63 VISTULA AVE, BELL PARK
RESIDENTIAL SUBDIVISION

project RESIDENTIAL SUBDIVISION

revision	date
rev. A	24.07.25
rev. B	24.08.05
rev. C	25.02.25
rev. D	30.06.25
AMENDMENT	30.06.26
RFI	03.07.26

EXISTING SITE PLAN
scale 1: 200 @ A3 sheet

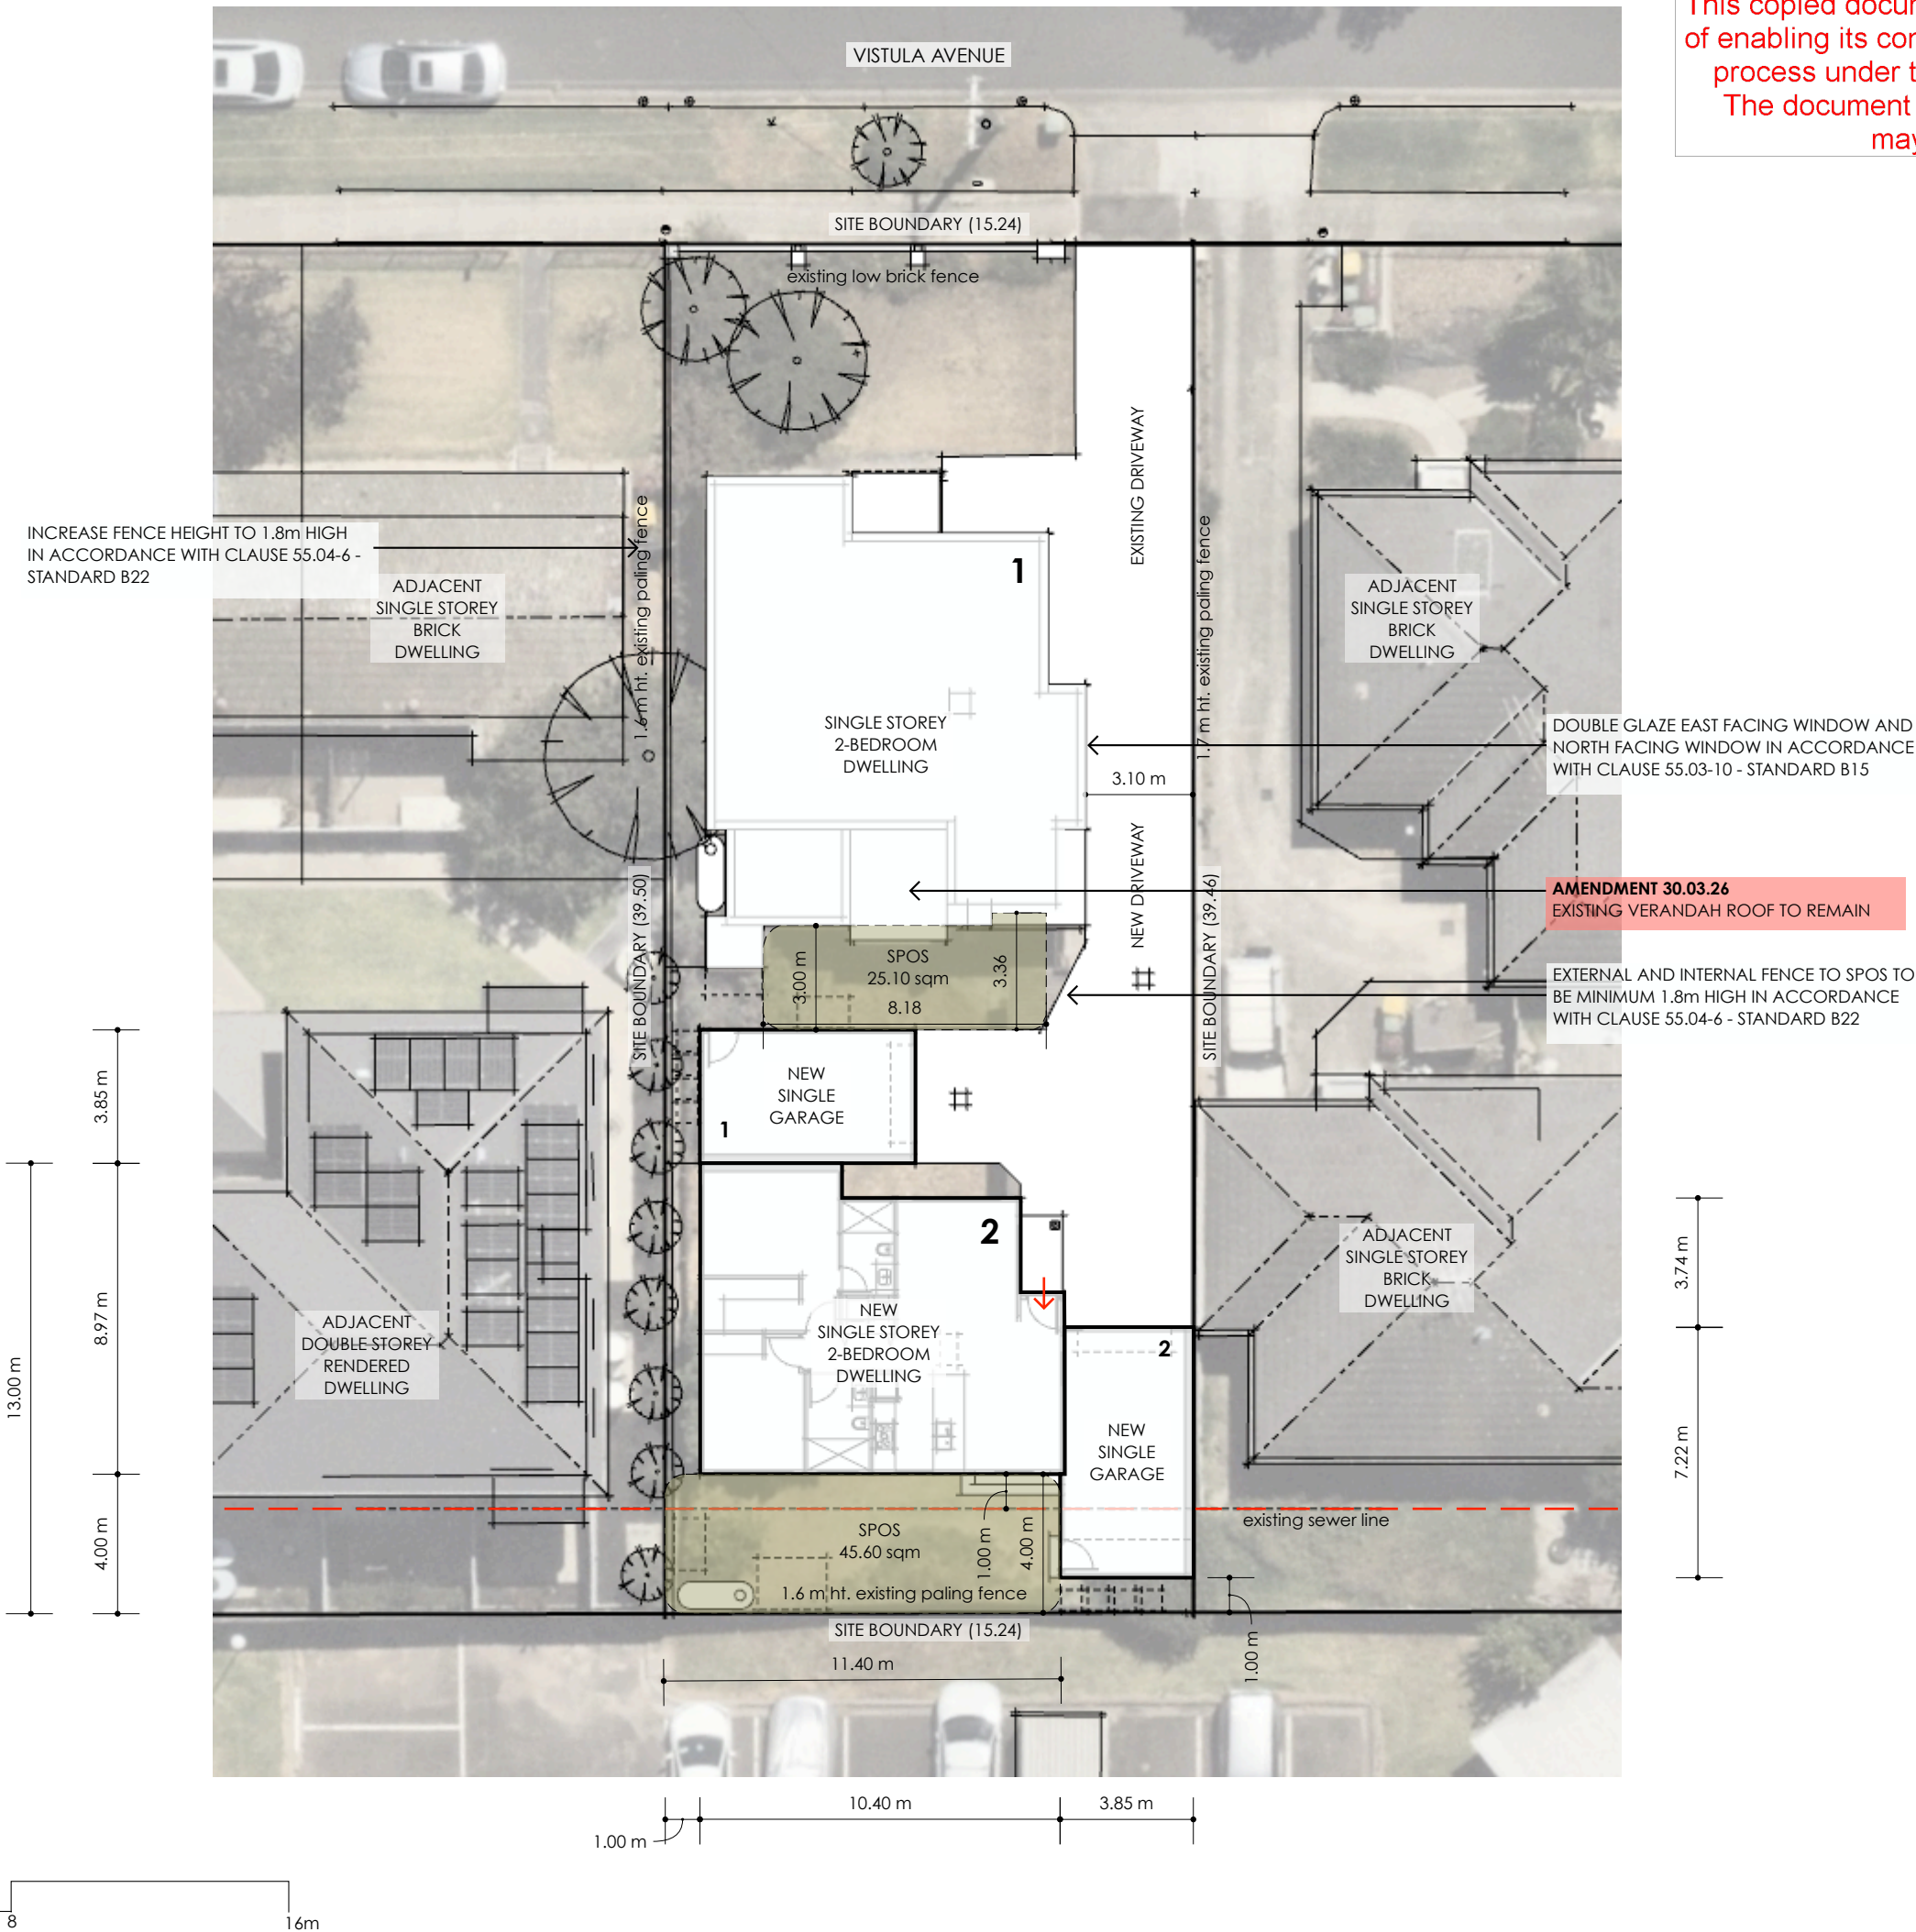
- EXISTING REAR VERANDAH ROOF TO REMAIN
- DWELLING 2 FINISHED FLOOR LEVEL AND OVERALL BUILDING HEIGHT RAISED TO COMPLY WITH BUILDING REGULATIONS FLOOD LEVEL REQUIREMENTS
- EXISTING DWELLING 1 INTERNAL LAYOUT TO REMAIN AS EXISTING

AMENDMENT 30.03.26
EXISTING INTERNAL LAYOUT OF DWELLING
1 TO REMAIN AS EXISTING

AMENDMENT 30.03.26
EXISTING VERANDAH ROOF TO REMAIN

DESIGN RESPONSE
scale 1: 200 @ A3 sheet

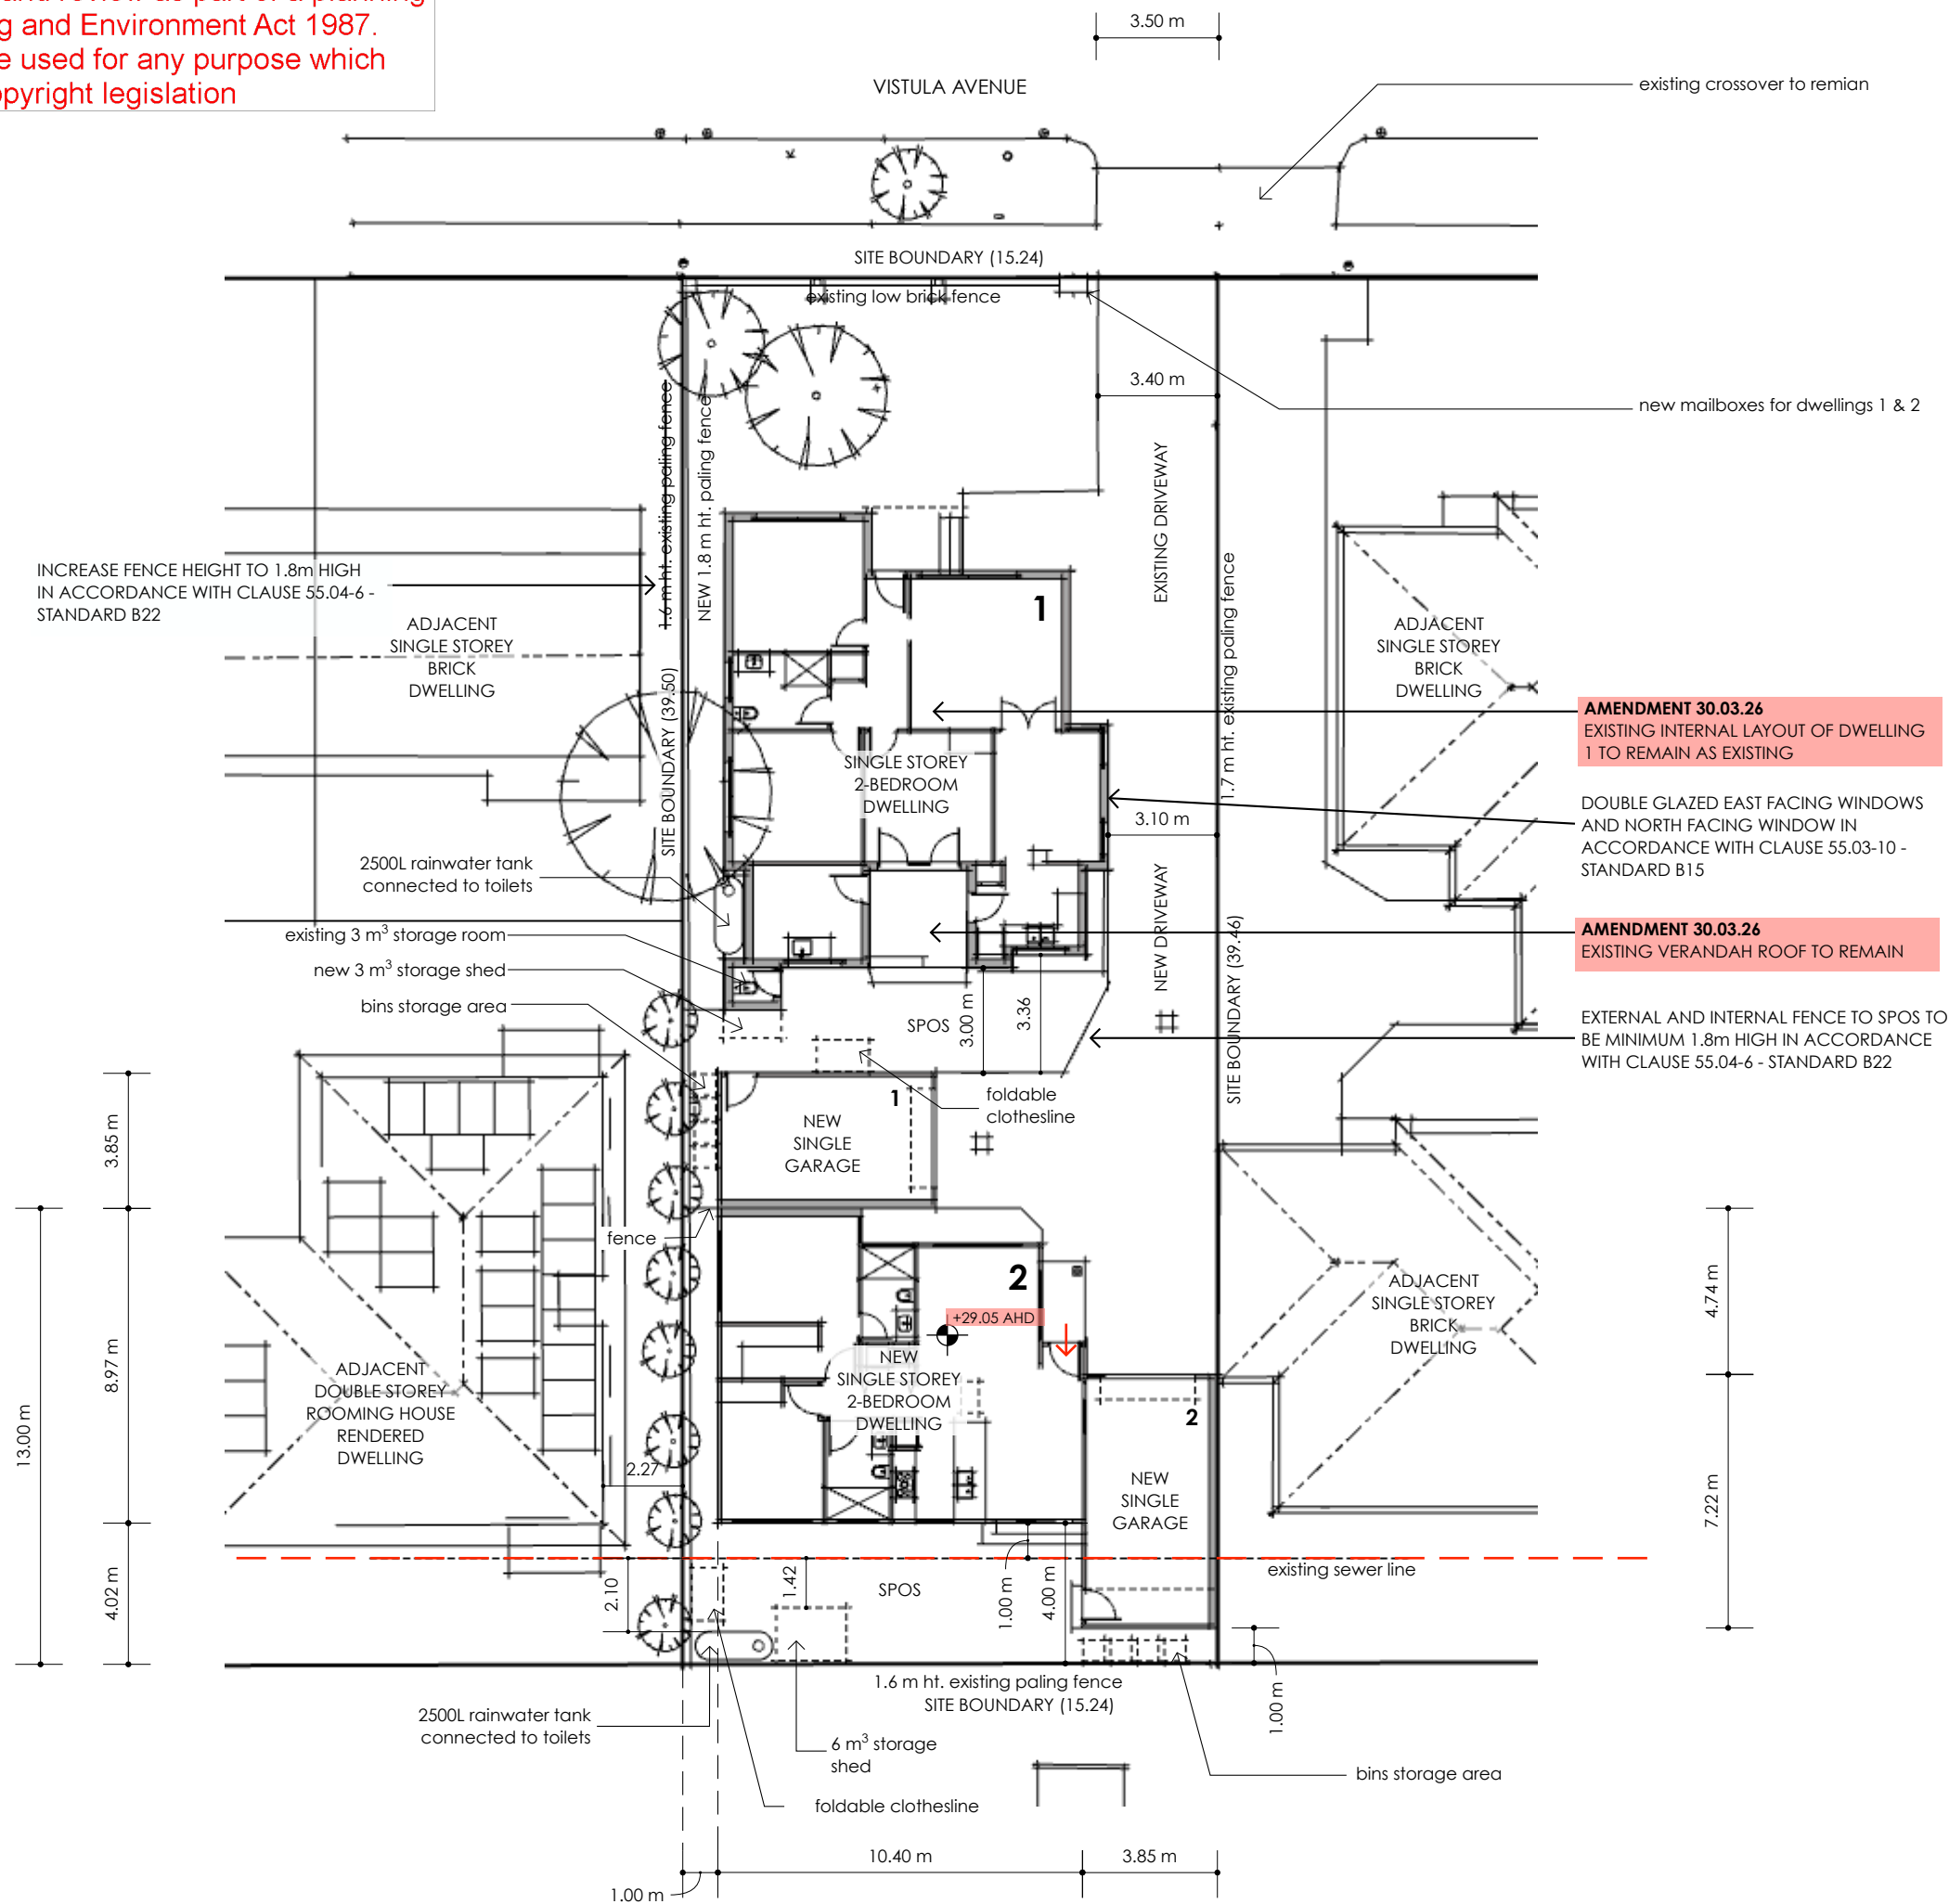
AMENDMENT 30.03.26

- EXISTING REAR VERANDAH ROOF TO REMAIN

- DWELLING 2 FINISHED FLOOR LEVEL AND OVERALL BUILDING HEIGHT RAISED TO COMPLY WITH BUILDING REGULATIONS FLOOD LEVEL REQUIREMENTS

- EXISTING DWELLING 1 INTERNAL LAYOUT TO REMAIN AS EXISTING

AMENDMENT 30.03.26

EXISTING VERANDAH ROOF TO REMAIN

project	RESIDENTIAL SUBDIVISION		
drawing	PA09	FLOOR PLAN - EXISTING DWELLING MODIFICATION	
address	63 VISTULA AVE BELL PARK		
date	July 2026		
project number	24048	PA	
po box 7076	geelong	west vic	3218
		t	1300 438 877
	info@theplanningprofessionals.com.au		
	abn 89 007 435 565

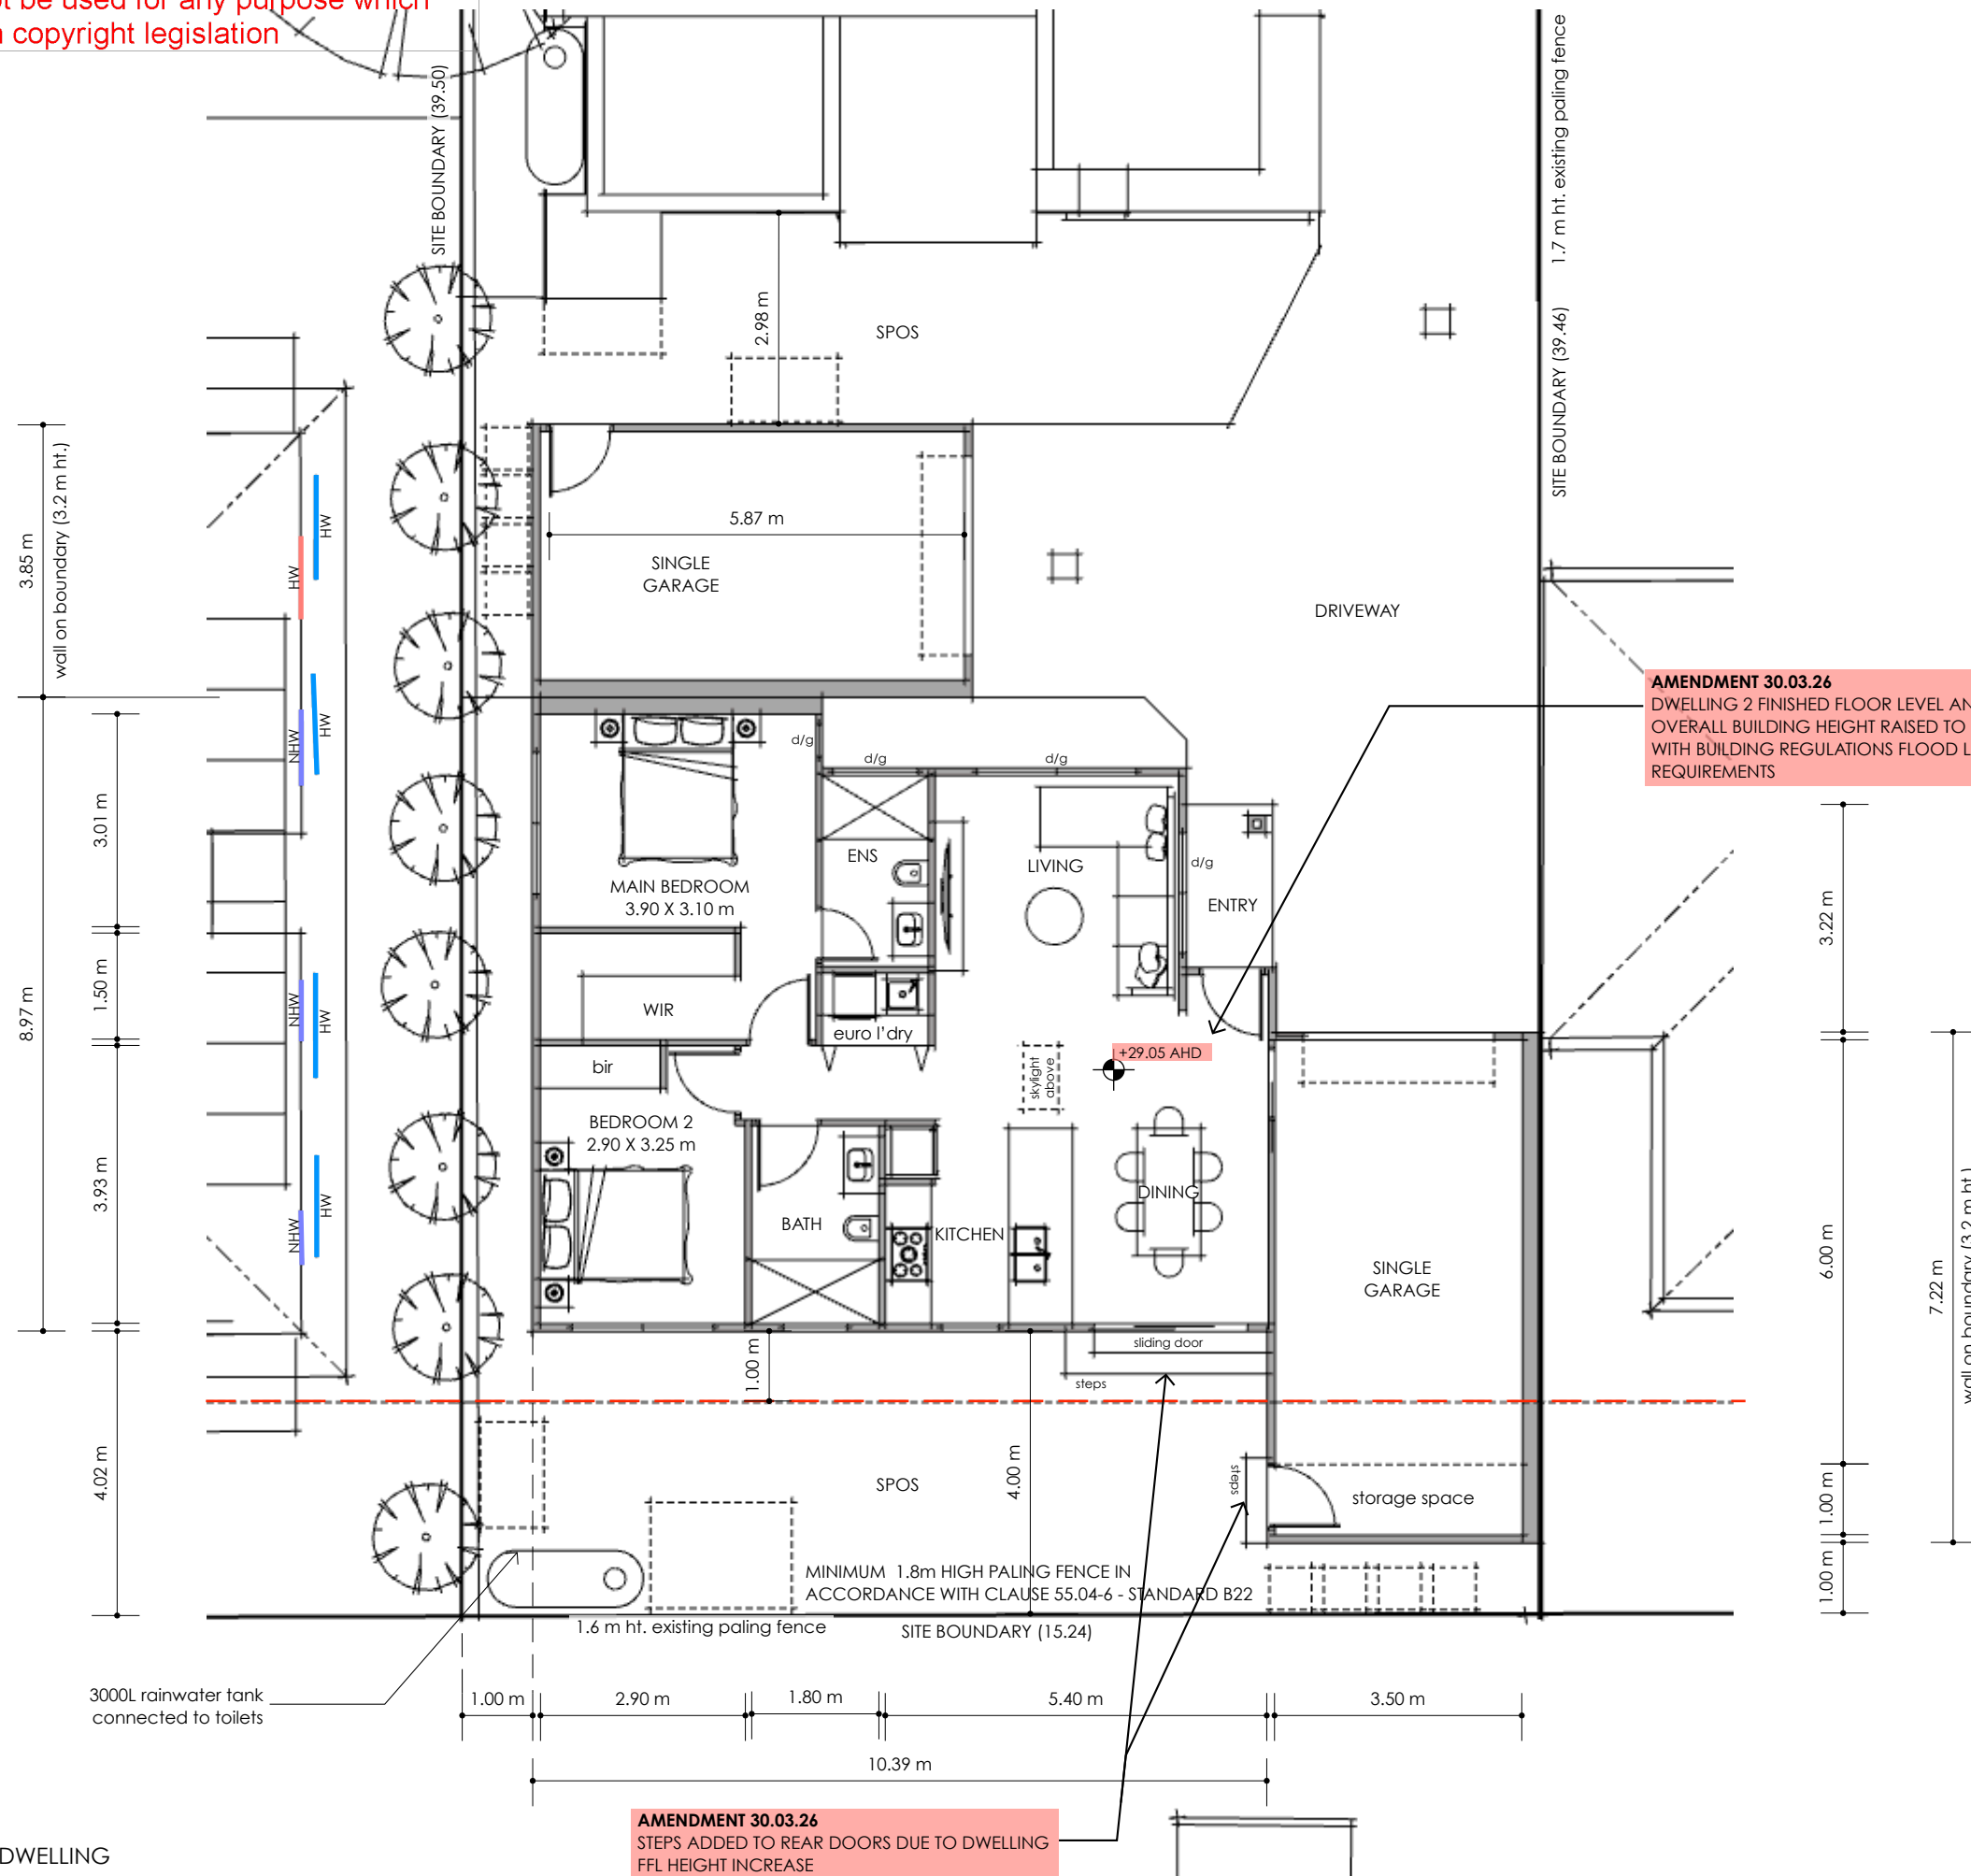
- AMENDMENT 30.03.26**
- EXISTING REAR VERANDAH ROOF TO REMAIN
- DWELLING 2 FINISHED FLOOR LEVEL AND OVERALL BUILDING HEIGHT RAISED TO COMPLY WITH BUILDING REGULATIONS FLOOD LEVEL REQUIREMENTS
- EXISTING DWELLING 1 INTERNAL LAYOUT TO REMAIN AS EXISTING
